SUNDRY NOTICES AND REPORTS ON WELLS

**EVGSAU 2801-005W
P&A Procedure**

Maverick Resources
Well: EVGSAU 2801-005W
API# 30-025-26382

EAST VACUUM GB-SA UNIT 2801-005W

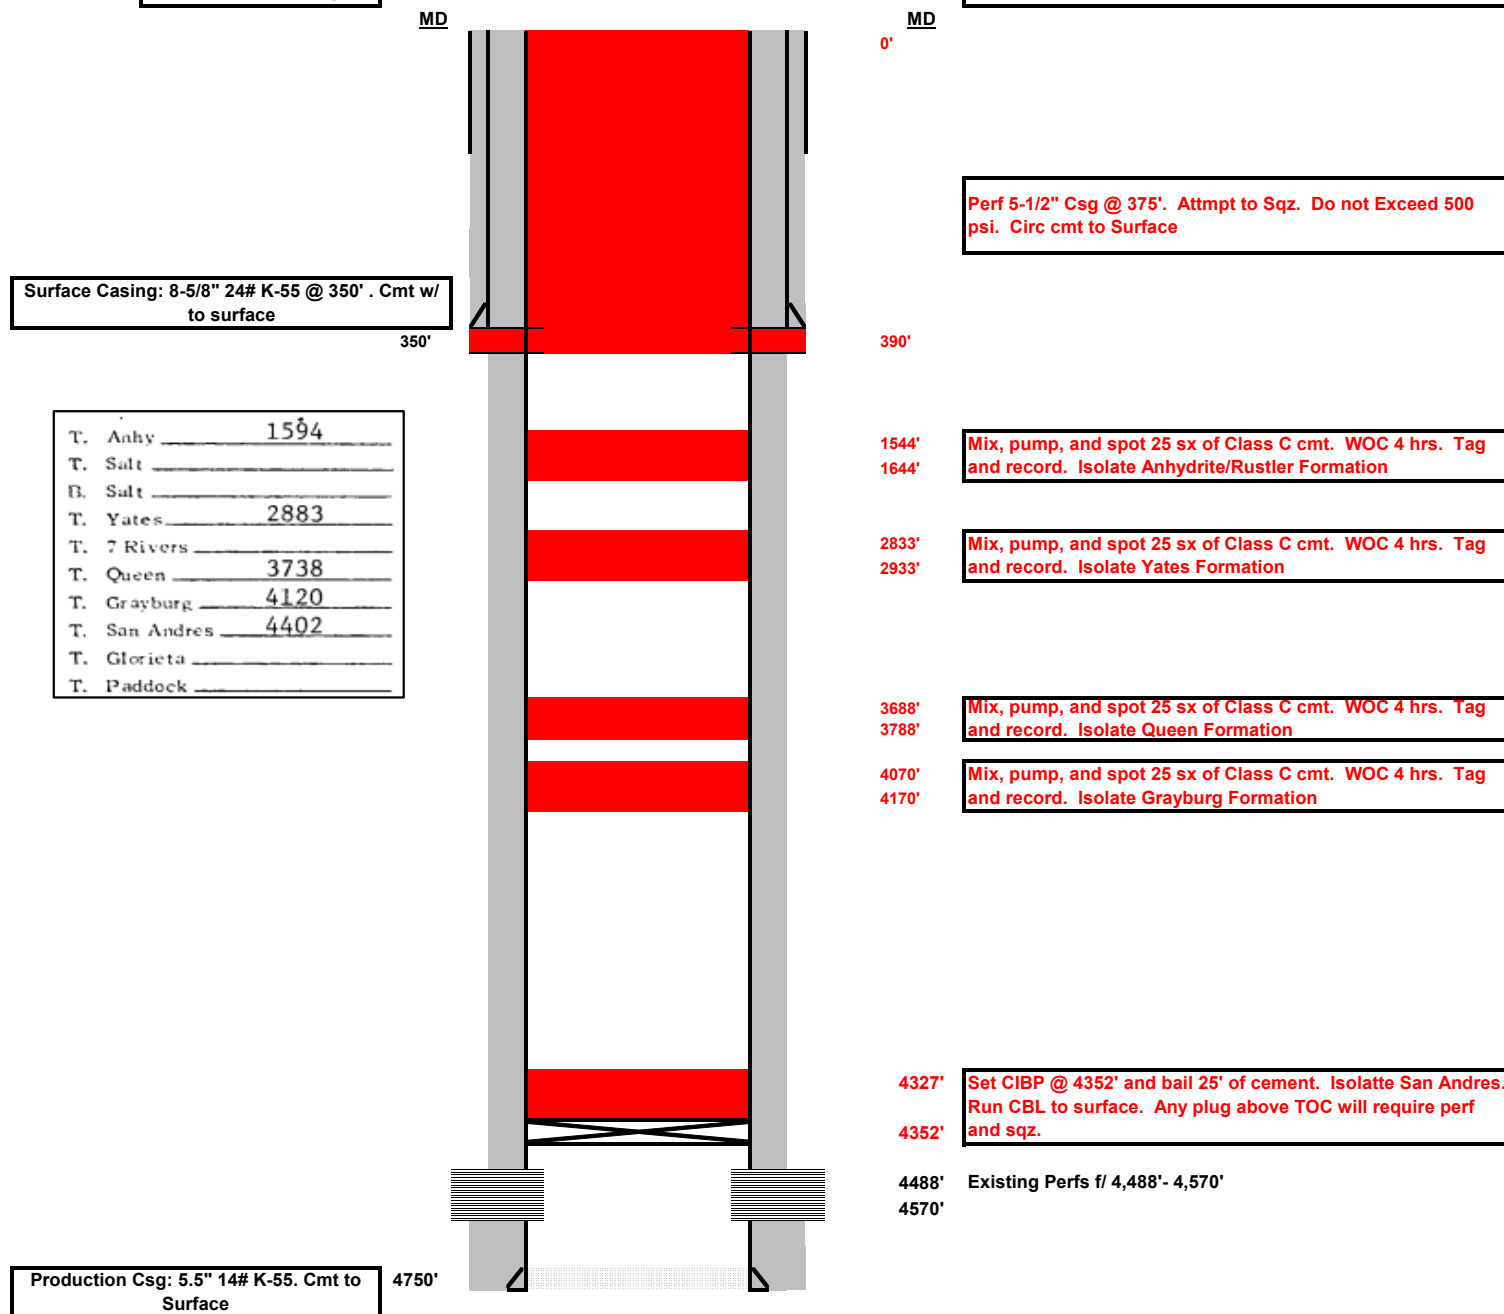
Perfs may change depending on CBL

RUN CBL if none on file

4" diameter 4' tall Above Ground Marker
